Agenda Item # 6

SUB-003550-2025

Subdivision Name:
Resubdivision of Lot 10, Block C, First Addition to
Pinewood Subdivision

**RESUBDIVISION OF LOT 10, BLOCK C,
FIRST ADDITION TO PINEWOOD RIVER SUBDIVISION**

DETAIL SITE PLAN

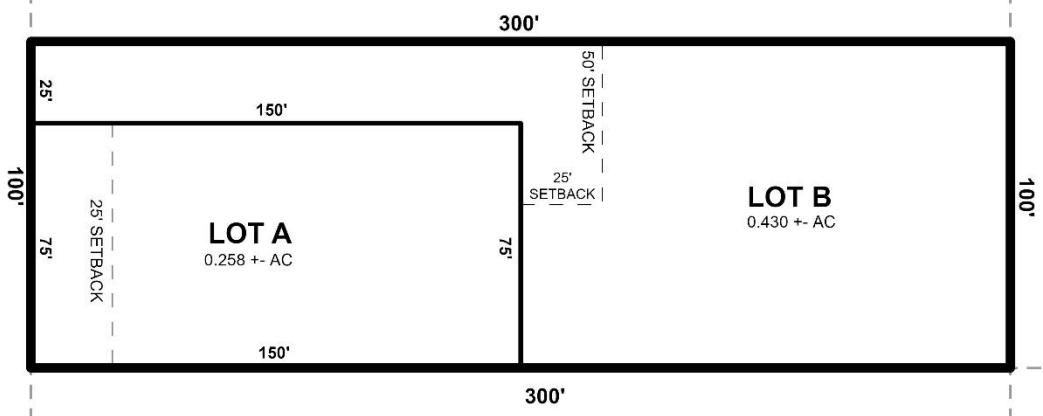
The site has frontage on Kent Road, a minor street without curbing or gutter improvements requiring a 60-foot-wide right-of-way. Sufficient right-of-way is illustrated on the preliminary plat making additional dedication unnecessary. This information should be retained on the Final Plat, if approved.

The lots, as proposed, exceed the minimum size requirements for lots served by public water and sanitary sewer in an R-1 Suburban district and are appropriately labeled with this information in square feet and acres on the preliminary plat. If approved, this information should be retained on the Final Plat; alternatively, a table providing the same information will suffice.

Proposed Lot B may be considered a “flag lot,” with a 25-foot-wide “pole” providing access to Kent Road. Section 6.C.9.(b) of the Subdivision Regulations discourages flag-lot designs unless similarly shaped lots are common within the vicinity or unusual circumstances exist. Flag lots are not common in the surrounding area; however, the applicant provides the following justification:

Proposed Lot A meets the minimum 60-foot width requirement of Section 6.C.2(b)(2) for residential lots located within the suburban sub-district.

A 25-foot front yard setback is illustrated on the preliminary plat where each lot is at least 60-feet wide, in compliance with Section 6.C.8. of the Subdivision Regulations and Article 2, Section 64-2-5.E. of the Unified Development Code (UDC) for lots in the R-1 Suburban district.

1. Retention of the 60-foot-wide right-of-way along Kent Road on the Final Plat;
2. Retention of the lot sizes in square feet and acres on the Final Plat, or provision of a table on the Final Plat with the same information;
3. Retention of the 25-foot front yard setback along Kent Road on the Final Plat where each lot is at least 60 feet in width;
